**Application for a Certificate of Appropriateness**

ADDRESS OF PROPERTY	<i>1309 Lexington Avenue, Dilworth Local Historic District</i>	<i>HDC 2012-047</i>
SUMMARY OF REQUEST	<i>New Front Entry Cover</i>	
OWNERS	<i>David &amp; Jennifer Reed</i>	
APPLICANT	<i>Kraig Magus of Don Duffy Architecture</i>

Reed Residence, 1309 Lexington Avenue  
 'Proposed' Front Elevation  
 Scale: 1/8"=1'-0"  
 Don Duffy Architecture  
 April 17, 2012

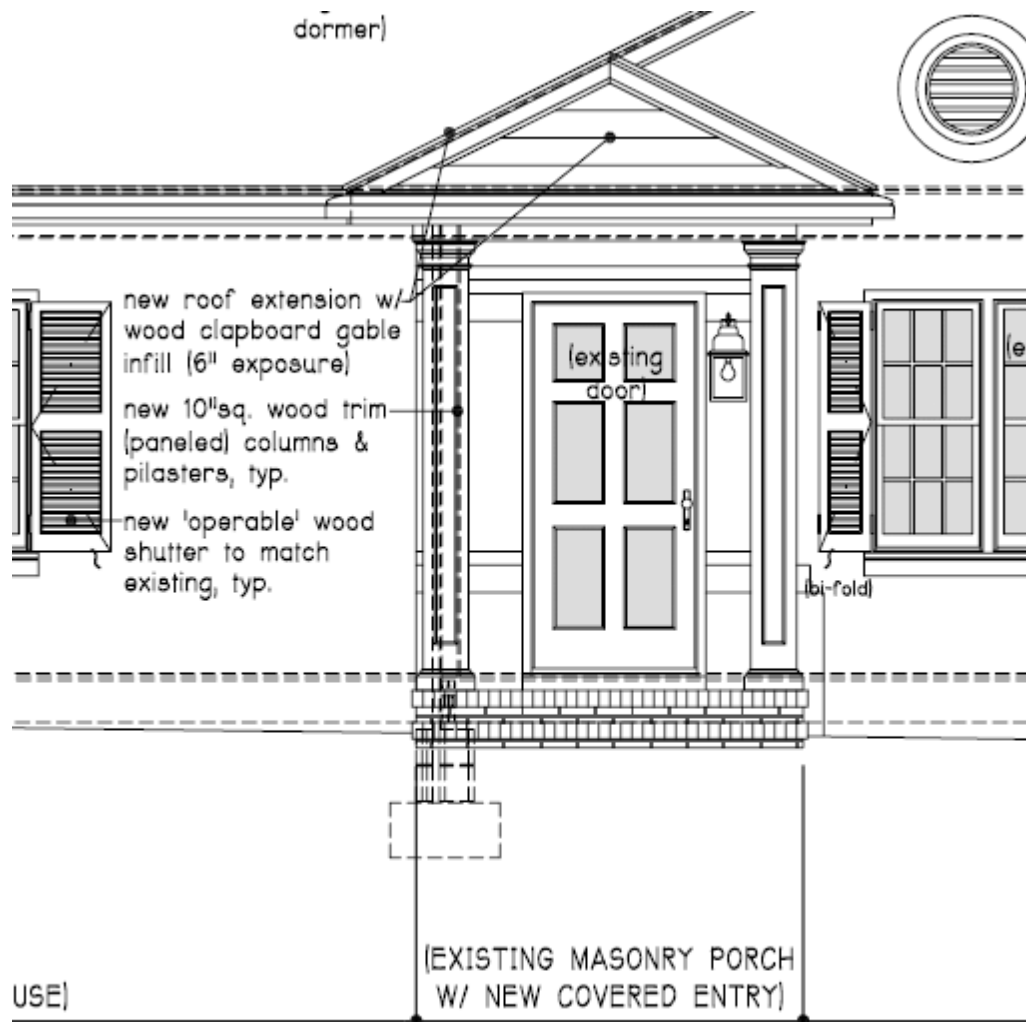
This project would place a small roof cover over the existing front entrance to this house. The roof would project from the house and would be supported by two ten inch square wooden columns with complimentary pilasters installed on the façade of the house. The columns are detailed in the architectural style of the house.

All of this work would be done over the existing entrance stoop.

The front porch entrance roof appears to meet all relevant HDC design guidelines.

There are new wooden shutters proposed on the plans as well on the façade of the house. There is a suite of windows to the right of the entrance door to the house that consists of two 6/6 double hung windows flanking an 8/8 center window. The [proposed shutters for this window suite are bi-fold, and would if closed cover the flanking smaller windows, but not the larger center window. The HDC must decide if the design of this suite of windows warrants an exception to HDC policy, which requires that shutters, if closed, must be of a size that would cover the window they are associated with.
